**Recommended Amendments to the  
2009 International Residential Code**  
North Central Texas Council of Governments region

The following sections, paragraphs, and sentences of the *2009 International Residential Code* are hereby amended as follows:

FIGURE R602.6.1  
TOP PLATE FRAMING TO ACCOMMODATE PIPING

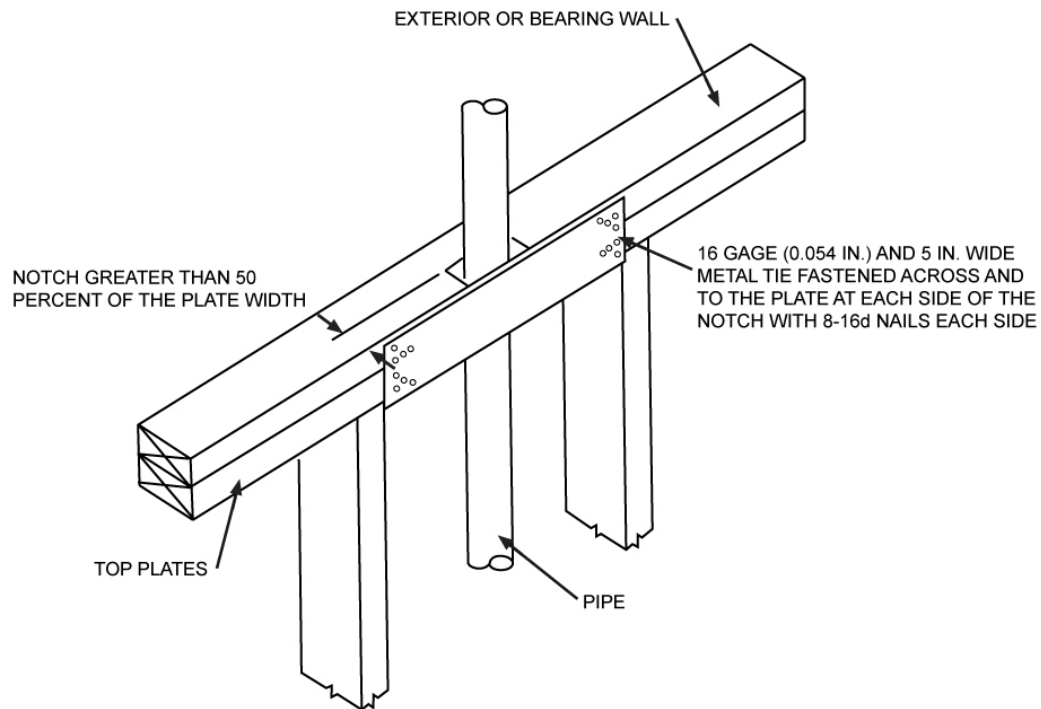
**R602.6.1 Drilling and notching of top plate.** When piping or ductwork is placed in or partly in an exterior wall or interior load-bearing wall, necessitating cutting, drilling or notching of the top plate by more than 50 percent of its width, a galvanized metal tie not less than 0.054 inch thick (1.37 mm) (16 Ga) and 5 inches (127 mm) wide shall be fastened across and to the plate at each side of the opening with not less than eight 10d (0.148 inch diameter) having a minimum length of 1 ½ inches (38 mm) at each side or equivalent. Fasteners will be offset to prevent splitting of the

top plate material. The metal tie must extend a minimum of 6 inches past the opening. See figure R602.6.1.

**\*\*Figure R602.6.1; delete the figure and insert the following figure:**
